Majors Bay Reserve Masterplan and Passive Recreation Precinct

COMMUNITY ENGAGEMENT REPORT (DETAILED DESIGN 14 OCT – 27 NOV)

28 November 2022

PUMP TRACK I CONCEPT DESIGN 5. MASTERPLAN

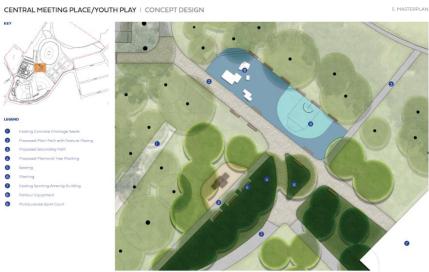
Question	Feedback
How much air would you like the jump track to offer?	 Lots Some. But maybe some tabletops on an alternative line. Having a some close pumps that can be gapped by more confident riders is always nice, as is a spine line to transition Line of gap jumps Ability to transfer between paths/lines
What materials should the jump track include? E.g. wooden table tops	 Asphalt but an easier area for smaller kids in synthetic/rubber Ideally all asphalt so my skateboard and kids scooters can also carve it up in addition to the bikes
Other feedback	 Make sure the detail is attended to with humps, as kids who have trick scooters can easily bottom out plus would damage track. Make sure minimum vertical radii are set to avoid bottoming out and adhered to in construction. I love both terrey hills and barder ridge. I like the flow and options at barren ridge but would love to see clearer more divergent lines mainly to help traffic when it's busy with any abilities. Ideally the 3yo on a 3 wheel scooter and the 14 yo manual ing all the pumps can be on at the same time and safe. On my skateboard I love the flow as much as possible. Native landscaping looks good Natural surveillance – good as is close to road Needs multiple access points Move pump track towards junior diamond and away from senior diamond to minimize baseballs entering the area Shelter would be good for rainy days No grass infills to the track, infills should be native planting

Deakin St Boardwalk

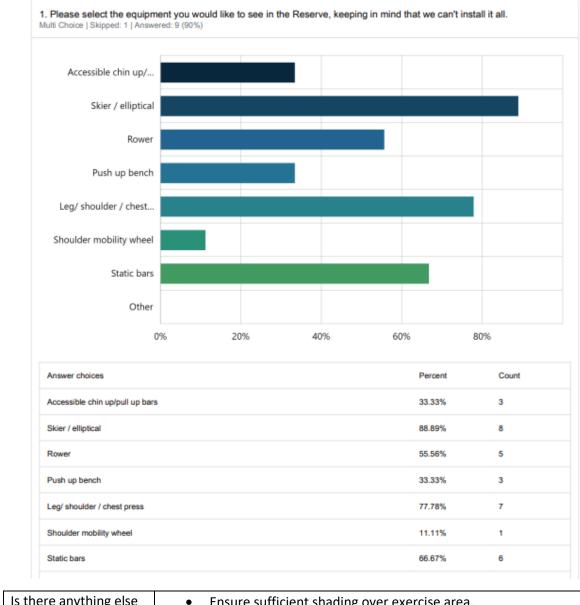
The details of the	Broad support for the idea of a boardwalk
boardwalk are under	Prioritise privacy for residents of Deakin St and keep them involved in
investigation. Is there	the planning
anything we should be	Extend foreshore track to Wangal Reserve
aware of while we	Continuous walking path around Canada Bay
conduct further	Requests to reinstate kayak launch into masterplan, include in this
investigations?	design now to provide access to the bay
	Consider contamination and ecology, mangrove conservation,
	endangered migratory bird
	Viewing platform in the water

All Access Playground

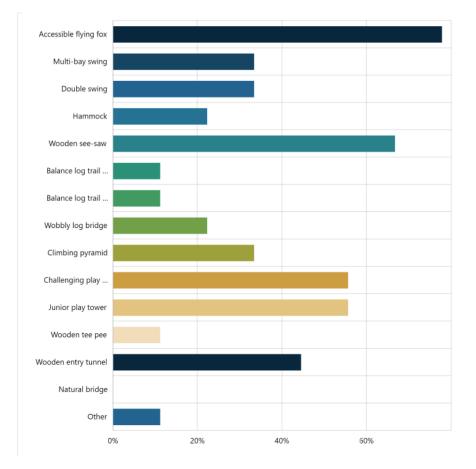
Answer choices	Percent	Count
Accessible flying fox	77.78%	7
Multi-bay swing	33.33%	3
Double swing	33.33%	3
Hammock	22.22%	2
Wooden see-saw	66.67%	6
Balance log trail option 1	11.11%	1
Balance log trail option 2	11.11%	1
Wobbly log bridge	22.22%	2
Climbing pyramid	33.33%	3
Challenging play structure	55.56%	5
Junior play tower	55.56%	5
Wooden tee pee	11.11%	1
Wooden entry tunnel	44.44%	4
Natural bridge	0%	0
Other	11.11%	1

Imaginative play, "shop", lots of swings, mature trees
